SERVICE BULLETIN

APPLICABILITY: 2019-2021 Forester with Seat Position Memory **NUMBER:** 07-197-21
SUBJECT: Seat Position Memory Switch- Loose Fit **DATE:** 06/29/21

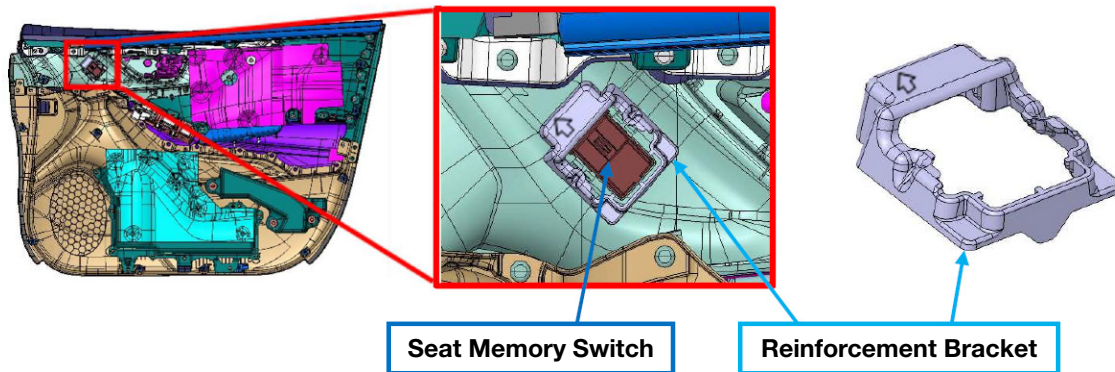
This bulletin announces availability of a NEW reinforcement bracket for the seat position memory switch. The bracket has been designed to fit on the existing switch without modification. The new bracket adds increased rigidity to optimize retention of the memory switch. Install this new bracket should a customer experience a loose-fitting seat memory switch in high ambient temperature conditions.

Part Description	Part Number
BRACKET-REINFORCEMENT, SWITCH	94286SJ100

Installation of Reinforcement Bracket

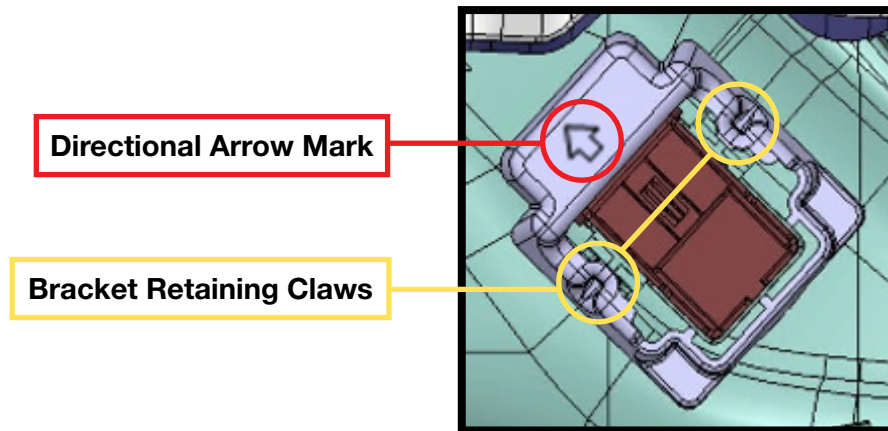
STEP 2) Align the bracket with the directional arrow as shown in the picture below. The bottom ridge of the bracket will line up with the groove in the switch.

STEP 3) Install the bracket by pushing it on to the door panel while aligning the retaining claws. Ensure the fitment and retention strength is sufficient. **CAREFULLY** reinstall all parts in reverse order and perform a function test of the seat memory switch. Reset the seat memory positions (and PRG memory height) gate to match the customer's previous selections.

Removal of Reinforcement Bracket

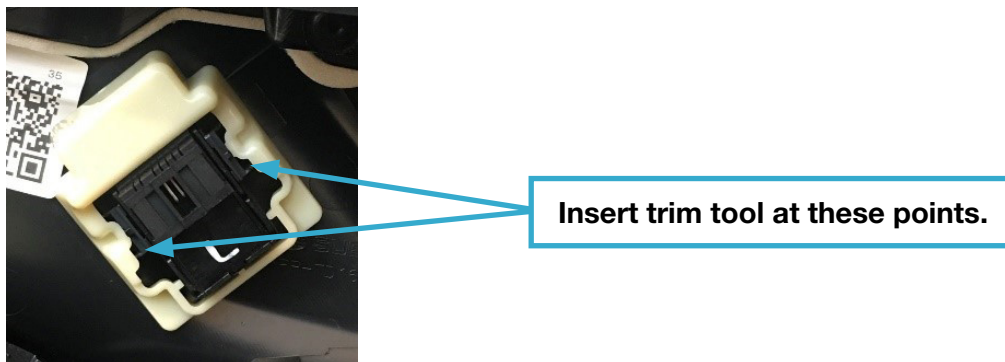
STEP 1) With the door trim panel removed, release the bracket hold claws with a small plastic trim tool.

Insert trim tool at these points.
